SOUTH WINDSOR ROAD SAFETY AUDIT

Route 5 (John Fitch Boulevard) between town lines of East Hartford and East Windsor

Exhibit 20: Representative Concept

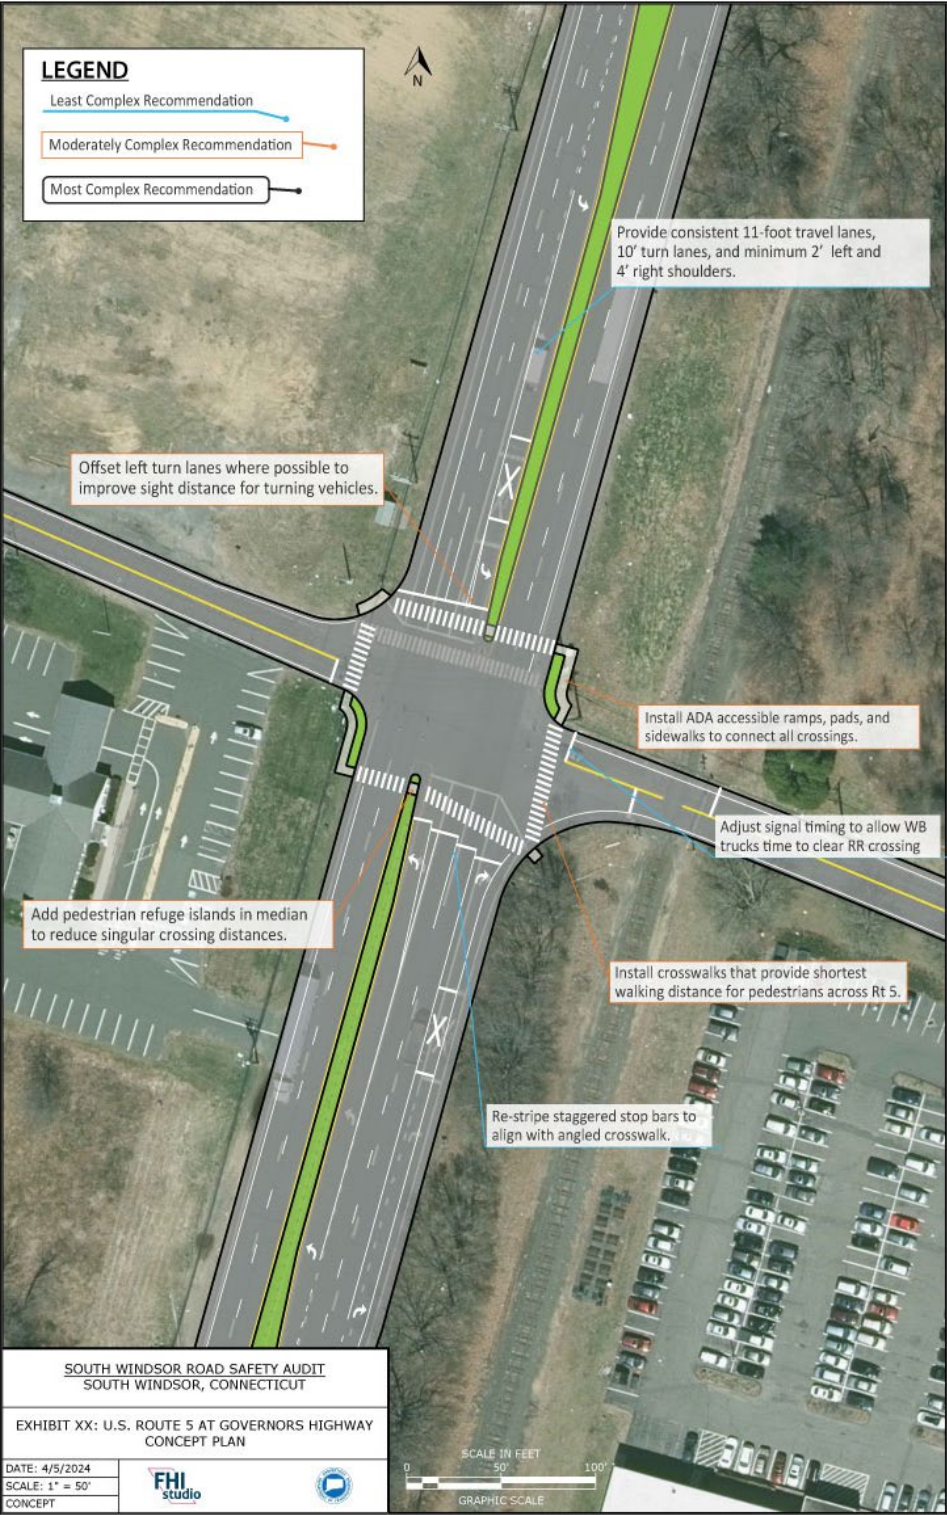
Exhibit 20 provides concept designs for a “standard” intersection along Route 5. Further detail is provided in the sections below.

Exhibit 21: Sullivan Avenue Recommendations

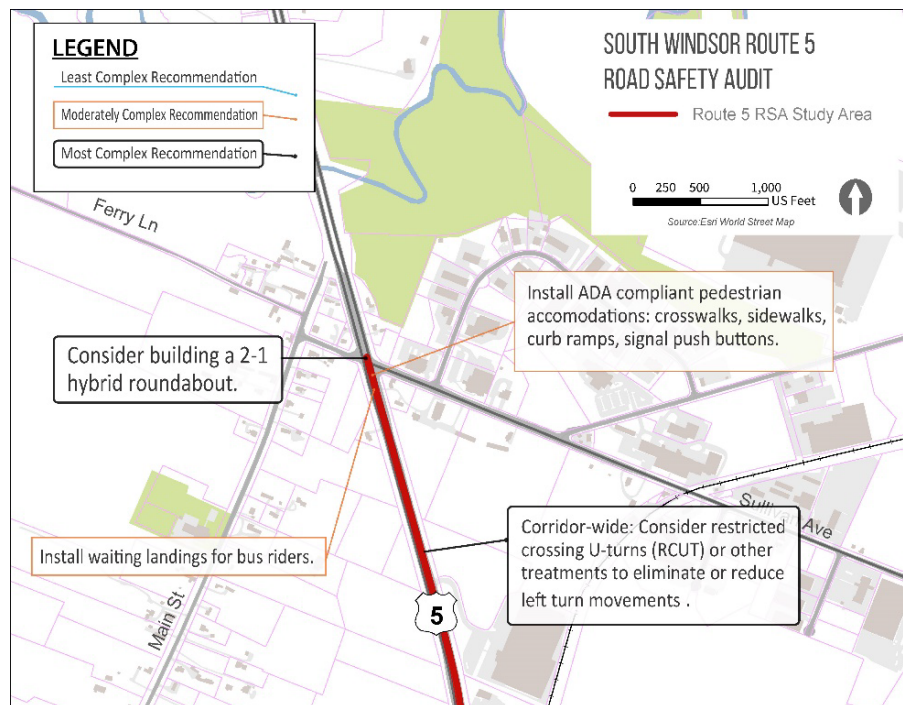
The recommendations for the intersection of Route 5 and Route 194 (Sullivan Avenue) are focused on pedestrians, bicyclists, and transit users while maintaining capacity for the high vehicular volumes through the corridor. The Town of South Windsor has identified this intersection as a “neighborhood hub” in the POCD, which emphasizes the importance for accommodating network users of all modes. Exhibit 21 displays the recommendations for the area.

- 1) Provide consistent 11' travel lanes, 10' turning lanes, and a minimum of 2' left and 4' right shoulders in order to reduce travel speeds and provide additional room for bicyclists. See Exhibit 20 for concept details.

- 1) Install landing pads at bus stop locations for transit riders.
 - **Next Step:** Municipality should contact DOT.BusStops@ct.gov to coordinate with CDOT to identify bus stop enhancements

- 2) Install appropriate ADA compliant pedestrian accommodations such as crosswalks across all legs of the intersection, sidewalks, curb ramps, signal push buttons, and pedestrian refuge islands.

- **Next Step:** LTA to contact DOT.TrafficEngineering@ct.gov
- 3) Offset left turn lanes to improve sight line for left-turning vehicles. Exhibit 20 displays concept details.

- 1) Consider a roundabout with one and two circulating lanes, which is most appropriate for a minor road intersecting a major road.
 - **Next Step:** Contact CRCOG for potential funding sources.
Check available ROW
- 2) Corridor-wide: Consider eliminating left-turn movements at unsignalized intersections by installing restricted crossing U-turns along Route 5. Several designs and variations are available for consideration.
 - **Next Step:** Contact CRCOG for potential funding sources.
Check available ROW

Exhibit 22: Strong Road Recommendations

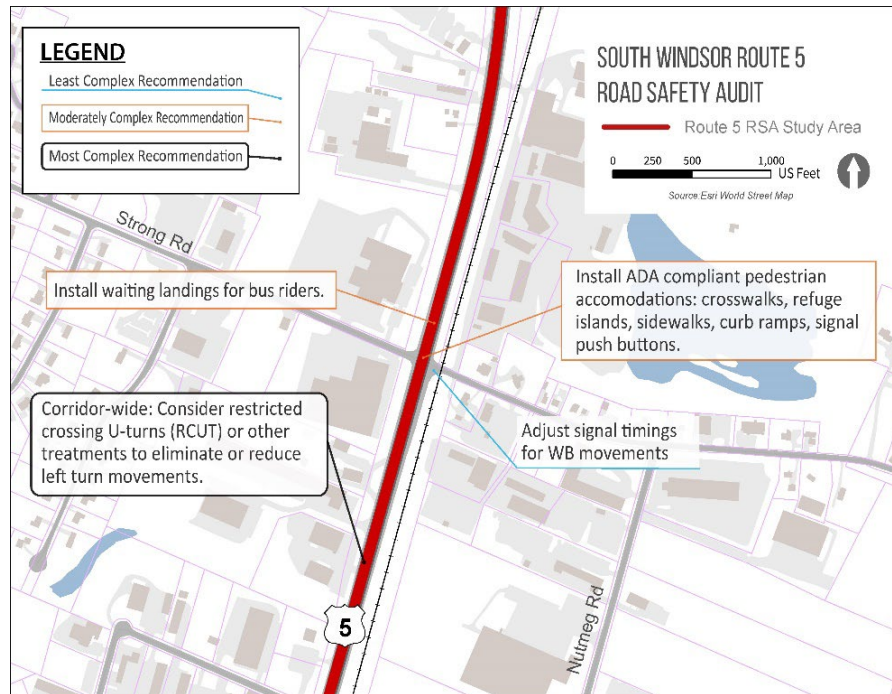
The intersection at Strong Road is adjacent to the freight rail line that runs parallel to Route 5. The focus at this intersection is also on pedestrian facilities and increased safety. Exhibit 22 displays a map with the recommendations.

- 1) Adjust signal timings so that westbound traffic, particularly trucks, do not get caught between the at-grade railroad crossing and the intersection.
 - **Next Step:** LTA to send request to DOT.TrafficEngineering@ct.gov
- 2) Provide consistent 11' travel lanes, 10' turning lanes, and a minimum of 2' left and 4' right shoulders. See Exhibit 20 for concept details.
 - **Next Step:** LTA to send request to DOT.TrafficEngineering@ct.gov
- 3) Re-stripe staggered stop bars to align with angled crosswalk. See Exhibit 20 for concept details. CTDOT to provide 11-foot travel lanes with the next resurfacing project. Typical Vendor-In-Place paving (VIP) cycles can range between 10 and 20 years.
 - **Next Step:** Contact DOT.TrafficEngineering@ct.gov for more information

- 1) Install landing pads at bus stop locations for transit riders.
 - **Next Step:** Municipality should contact Dot.BusStops@ct.gov to coordinate with CTDOT to identify bus stop enhancements
- 2) Install appropriate ADA compliant pedestrian accommodations such as crosswalks, sidewalks, curb ramps, signal push buttons, and pedestrian refuge islands. Traffic Signal is currently under consideration for a complete upgrade with design completion in FY

- **Next Step:** Contact DOT.TrafficEngineering@ct.gov for more information
- 3) Offset left turn lanes to improve sight line for left-turning vehicles. Exhibit 20 displays concept details.
 - **Next Step:** Contact DOT.TrafficEngineering@ct.gov for more information

- 1) Corridor-wide: Consider eliminating left-turn movements at unsignalized intersections by installing restricted crossing U-turns along Route 5. Several designs and variations are available for consideration.
 - **Next Step:** Check available ROW for feasibility. Town should consider applying for an Encroachment Permit. [Encroachment Permit \(ct.gov\)](https://www.ct.gov/transportation/encroachment-permit)

Exhibit 23: Pleasant Valley Road Recommendations

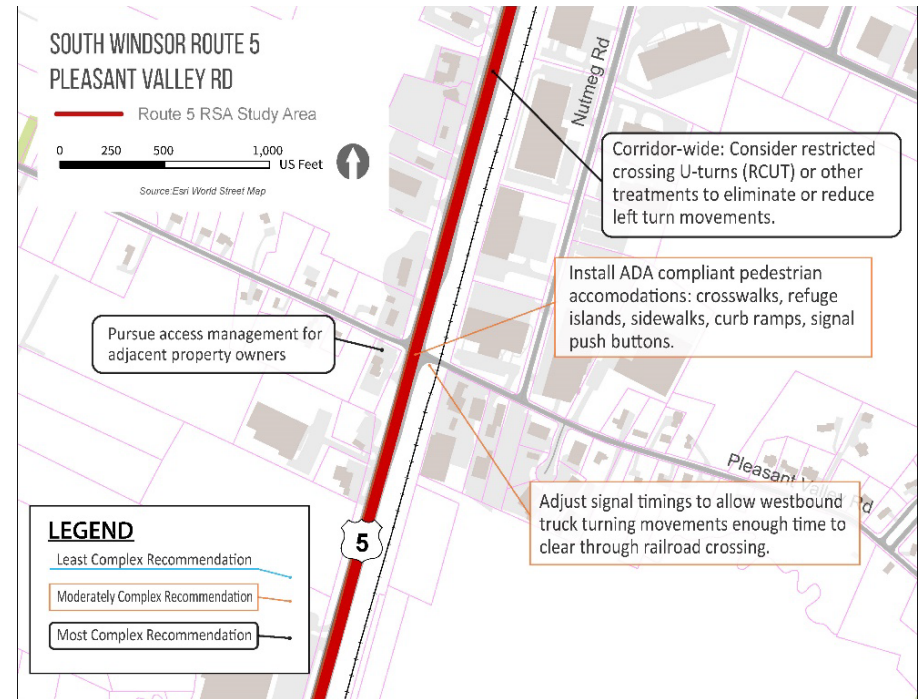
The recommendations at Pleasant Valley Road are like those at Strong Road and are shown below in Exhibit 23 but with an added emphasis on reducing the number of curb cuts and driveways. This intersection has been included in a state project for traffic signal improvements/replacement. Concerns and recommendations will be provided to the project engineer. Coordination will be required.

- 1) Adjust signal timings so that westbound traffic, particularly trucks, do not get caught between the at-grade railroad crossing and the intersection.
 - **Next Step:** Contact LTA to send request to DOT.TrafficEngineering@ct.gov
- 2) Provide consistent 11' travel lanes, 10' turning lanes, and a minimum of 2' left and 4' right shoulders. CTDOT to provide 11" travel lanes with the next resurfacing project. Typical Vendor-In-Place paving (VIP)

- 1) Install appropriate ADA compliant pedestrian accommodations such as crosswalks, sidewalks, curb ramps, signal push buttons, and pedestrian refuge islands. Town may install via Encroachment Permit. [Encroachment Permit \(ct.gov\)](https://www.ct.gov/dot/transportation/encroachment-permit). Traffic Signal is currently under consideration for a complete upgrade with design completion in FY 2027. Pedestrian amenities will be included. CTDOT Traffic Engineering will coordinate with the town.

- 2) Offset left turn lanes to improve sight line for left-turning vehicles in order to reduce travel speeds and provide additional room for bicyclists. See Exhibit 20 for concept details.

- 1) Corridor-wide: Consider eliminating left-turn movements at unsignalized intersections by installing restricted crossing U-turns along Route 5. Several designs and variations are available for consideration.

- 2) Pursue access management in concert with adjacent property owners due to many curb cuts near the intersection.

Exhibit 24: Chapel Road Recommendations

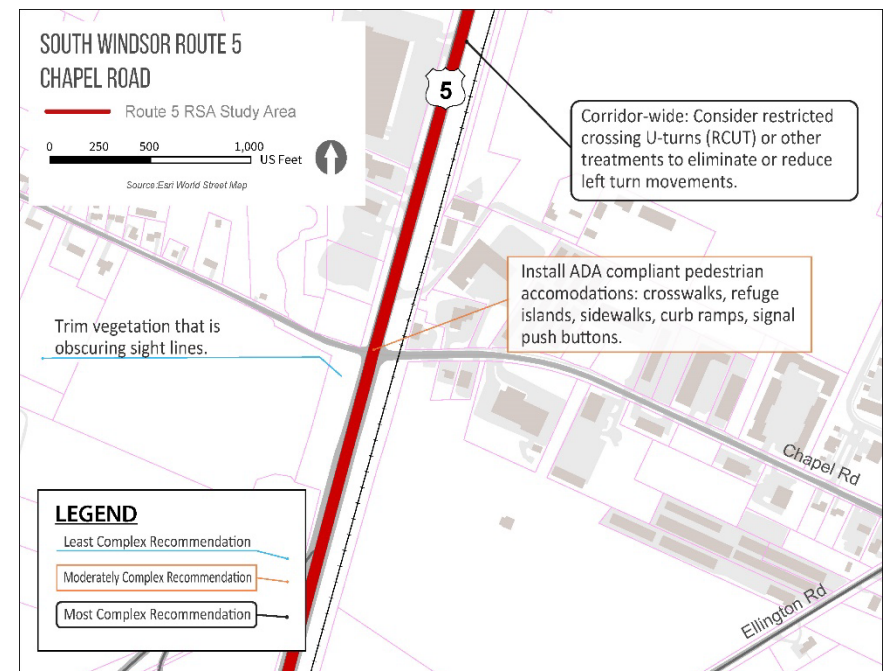
Chapel Road should be fitted with similar pedestrian accommodations to the previous intersections. The southwest corner has ample vegetation that should be trimmed to reduce the obstruction of sight lines.

- 1) Adjust signal timings so that westbound traffic, particularly trucks, do not get caught between the at-grade railroad crossing and the intersection.
 - **Next Step:** Contact LTA to send request to DOT.TrafficEngineering@ct.gov
- 2) Provide consistent 11' travel lanes, 10' turning lanes, and a minimum of 2' left and 4' right shoulders. CTDOT to provide 11-foot travel lanes with the next resurfacing project. Typical Vendor-In-Place paving (VIP) cycles can range between 10 and 20 years. See Exhibit 20 for concept details.
 - **Next Step:** Contact DOT.TrafficEngineering@ct.gov for more information

- 1) Install appropriate ADA compliant pedestrian accommodations such as crosswalks, sidewalks, curb ramps, signal push buttons, and pedestrian refuge islands.
 - **Next Step:** Town to apply for an Encroachment Permit. Town may install via Encroachment Permit. [Encroachment Permit \(ct.gov\)](#)
 - **Next Step:** For new crosswalk locations with or without RRFB, have the LTA contact DOT.TrafficEngineering@ct.gov
- 2) Offset left turn lanes to improve sight line for left-turning vehicles. See Exhibit 20 for concept details.
 - **Next Step:** Contact LTA to send request to DOT.TrafficEngineering@ct.gov

- 1) Corridor-wide: Consider eliminating left-turn movements at unsignalized intersections by installing restricted crossing U-turns along Route 5. Several designs and variations are available for consideration.
 - **Next Step:** Contact LTA to send request to DOT.TrafficEngineering@ct.gov
- 2) Pursue access management in concert with adjacent property owners due to many curb cuts near the intersection.
 - **Next Step:** Municipalities to initiate and coordinate access management with respected property owners

Exhibit 25: I-291 / Route 30 (Ellington Road) Recommendations

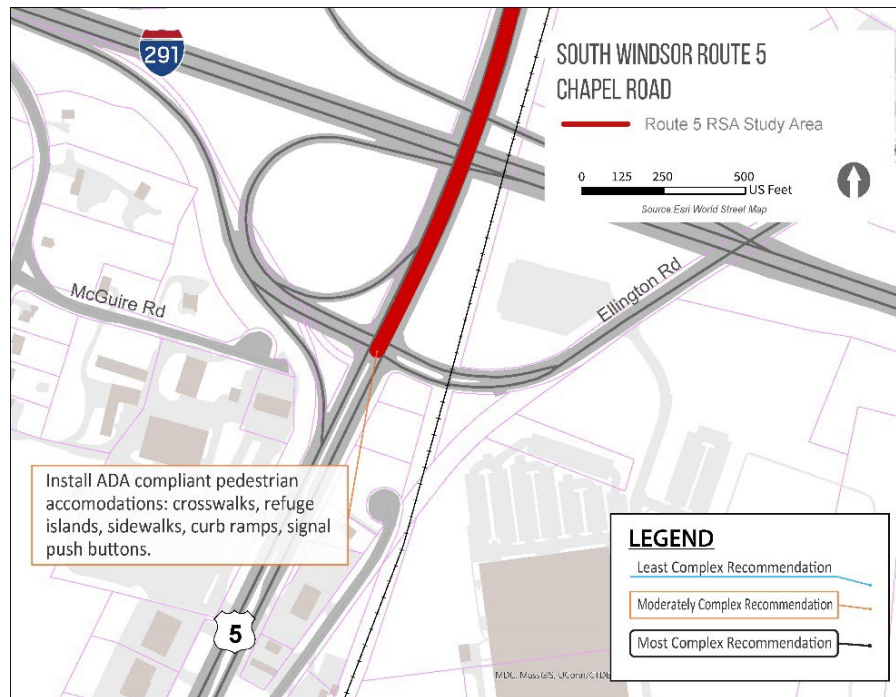
The intersection of Route 5 and Route 30 (Ellington Road) sees high volumes and many turning movements due to the I-291 eastbound ramps. There is no connection to a nearby sidewalk network, however there are pedestrian signal buttons. Recommendations at this intersection are focused on pedestrian safety and are shown in Exhibit 25.

- 1) Provide consistent 11' travel lanes, 10' turning lanes, and a minimum of 2' left and 4' right shoulders. CTDOT to provide 11-foot travel lanes with the next resurfacing project. Typical Vendor-In-Place paving (VIP) cycles can range between 10 and 20 years. See Exhibit 20 for concept details.
 - **Next Step:** Contact DOT.TrafficEngineering@ct.gov for more information

- 1) Install appropriate ADA compliant pedestrian accommodations such as crosswalks, sidewalks, curb ramps, signal push buttons, and pedestrian refuge islands.
 - **Next Step:** Contact CROCG for potential funding sources
 - **Next Step:** Town to apply for an Encroachment Permit. Town may install via Encroachment Permit. Encroachment Permit (ct.gov)
 - **Next Step:** For new crosswalk locations with or without RRFB, have the LTA contact DOT.TrafficEngineering@ct.gov
- 2) Offset left turn lanes to improve sight line for left-turning vehicles. See Exhibit 20 for concept details.
 - **Next Step:** Contact LTA to send request to DOT.TrafficEngineering@ct.gov
